Subject: Request for Class 2 Permissive Change

Reference: *[FCC ID] U4G004W*

Hereby we request a calss II permissive change for the Datalogic module DL-MSD30AG, FCC ID: U4G004W.
The module was removed from the interface board to solder it directly to the end user product. The module still fulfills the FCC requirements of a modular approval.

The new configuration: the SIP module has been moved to daughter

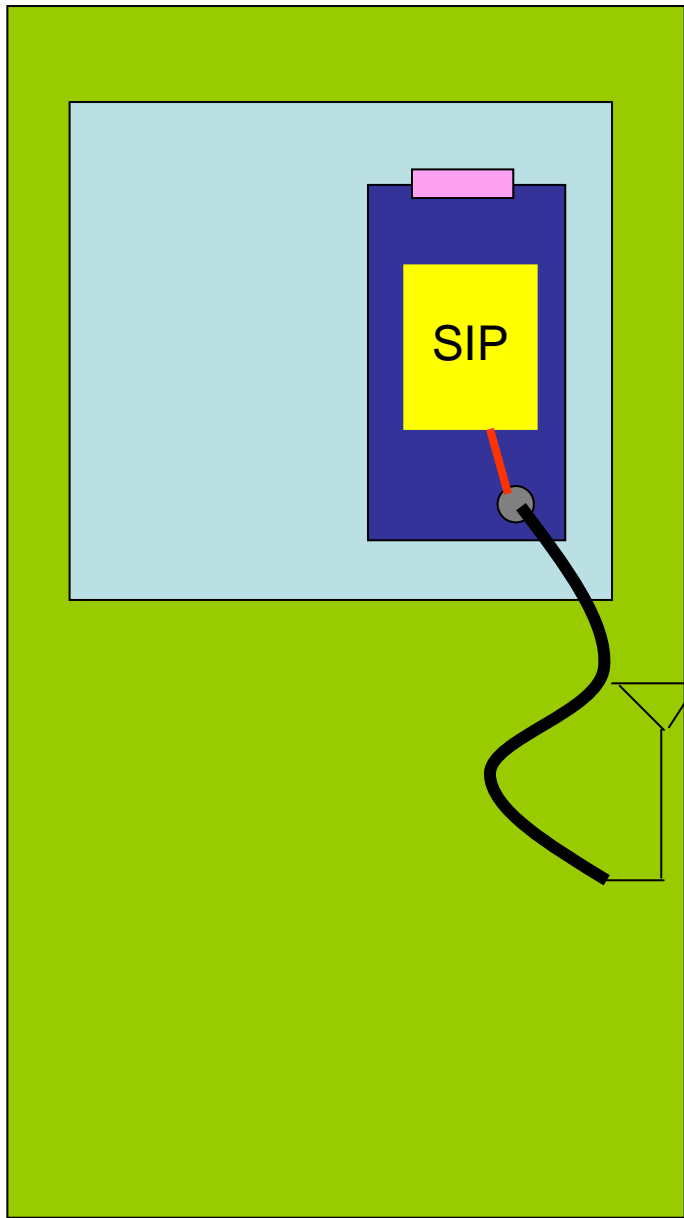
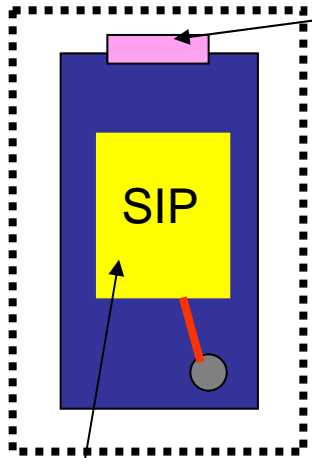
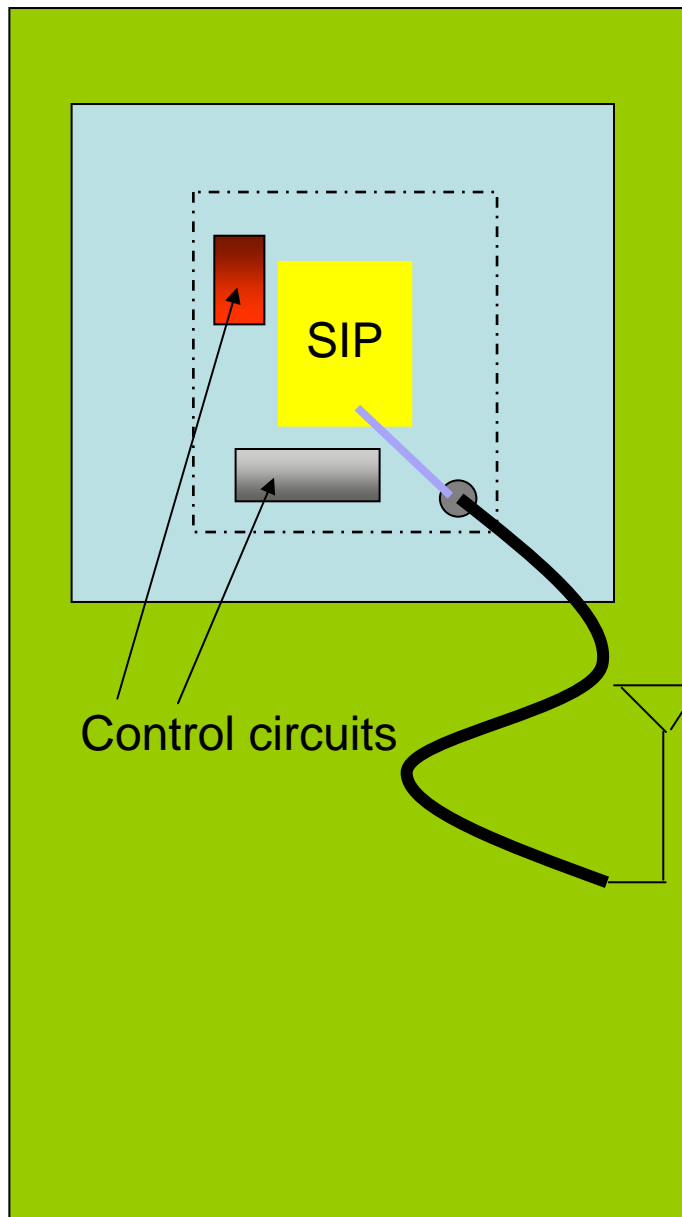
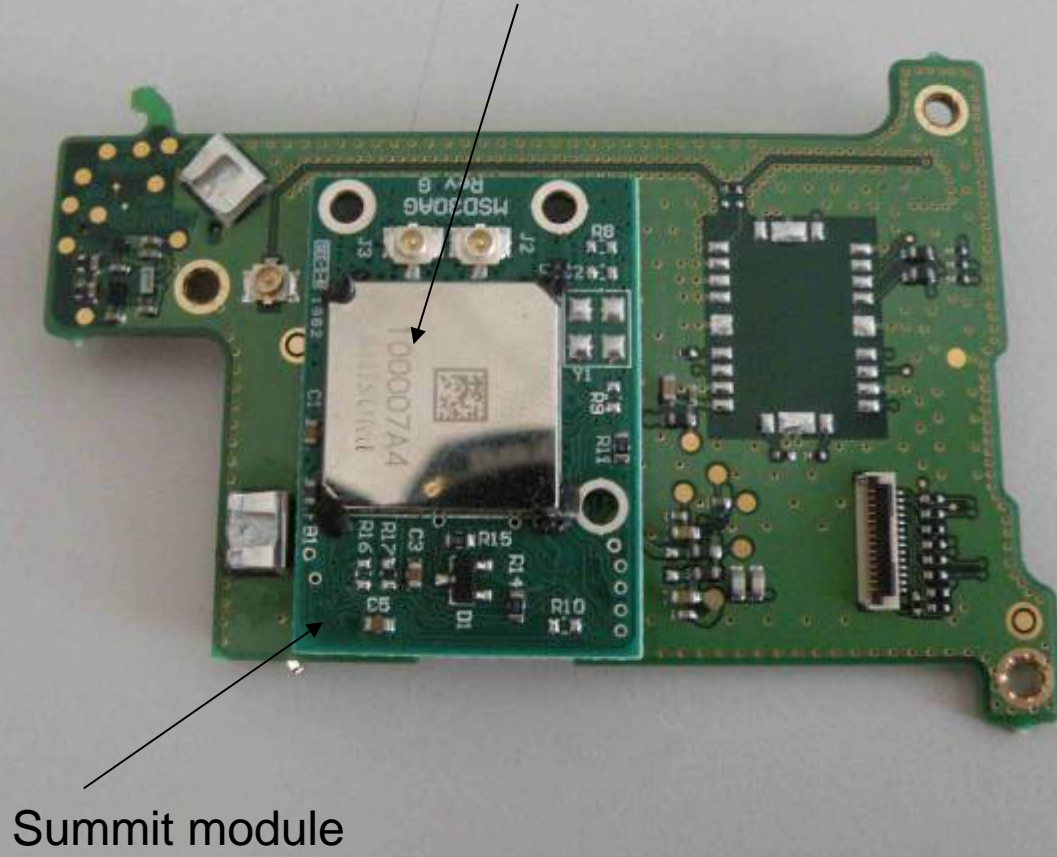
1. We solder the SIP module directly on the Daughter board
1. RF antenna trace is designed following the Application guide
1. There is the antenna connector
2. There is no digital connector
OUR IDEA IS TO MAKE THE FCC CERTIFICATION OF THIS PIECE OF PC AND INTEGRATE IT IN OUR MODULAR APPROVAL APPROACH
